Access Compliance Report Public Rights-of-Way (Curb Ramps)

Main Street: ANTONIO_PKWY Cross Street: N/A Location: NE

ADA ID: RPRK211118142203 Ramp Type: Type 1 - Perpendicular Diagonal Initial Pass/Fail: Pass Overall Compliance: No Severity Score: 11

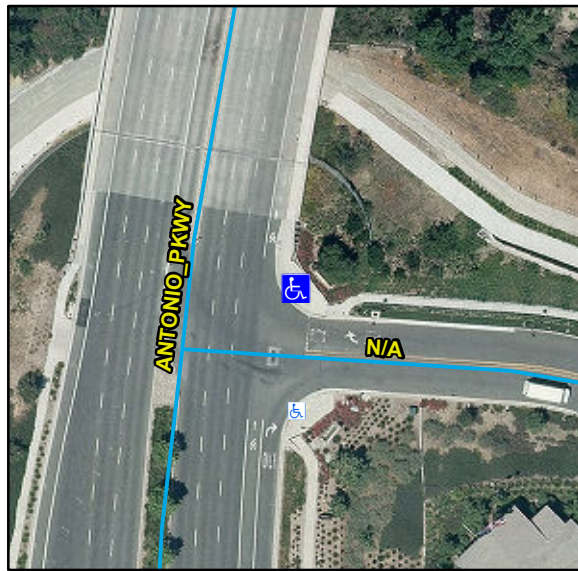
Compliance	Description	Data	Compliance	Description	Data
N/A	Ramp Length (in)	113	N/A	Flare Type LT	
Yes	Ramp Width (in)	48			Sloped
Yes	Ramp Run Slope (%)	6.1	Yes	Flare Slope LT (%)	8.3
Yes	Ramp Cross Slope (%)	0.3	N/A	Flare Traversable LT	Yes
N/A	Landing Present	Yes	N/A	Flare Type RT	
N/A	Landing Length (in)	31			Sloped
Yes	Landing Width (in)	48	Yes	Flare Slope RT (%)	8
Yes	Landing Run Slope (%)	1.3	N/A	Flare Traversable RT	Yes
Yes	Landing Cross Slope (%)	0.4	Yes	DWS Provided	Yes
N/A	Landing Movement Obstructed?	Yes	Yes	DWS Contrast	Yes
	Landing Movement Type	Guard Rail	Yes	DWS Length (in)	36
N/A	Landing Shared	No	Yes	DWS Full Width	Yes
N/A	Clear Space	Yes	Yes	DWS Offset Left (in)	0
N/A	Clear Space To Crosswalk (in)	48	Yes	DWS Offset Right (in)	N/A
N/A	Marked Crosswalk 1	No	N/A	Marked Crosswalk 2	No
	Crossing 1 Direction	W		Crossing 2 Direction	S
	Marked Crosswalk 1 Width (in)	N/A		Marked Crosswalk 2 Width (in)	N/A

N/A	Ramp Inside Crosswalk 1	N/A	Yes	Ramp Inside Crosswalk 2	N/A
	Crossing 1 Slope (%)	0.5		Crossing 2 Slope (%)	1.2
	Crossing 1 Cross Slope (%)	0.4		Crossing 2 Cross Slope (%)	2.5
Yes	Gutter Ponding	No	No	Curb Slope	5.7
Yes	Gutter Lip Height (in)	0		Road Run Slope (%)	1.3
No	Gutter Run Slope (%)	11.7		Road Cross Slope (%)	3.2
Yes	Gutter Cross Slope (%)	0.7			
Yes	Overall Surface Condition: Acceptable		Yes	Perp Joint Present	Yes
	Cross Gutter Present?	No		Spandrel Present?	No
	Replace Cross Gutter?	N/A		Replace Spandrel?	N/A

Remove & Replace Curb Ramp With Two New Directional Ramps or Equivalent. Remove & Replace Gutter.
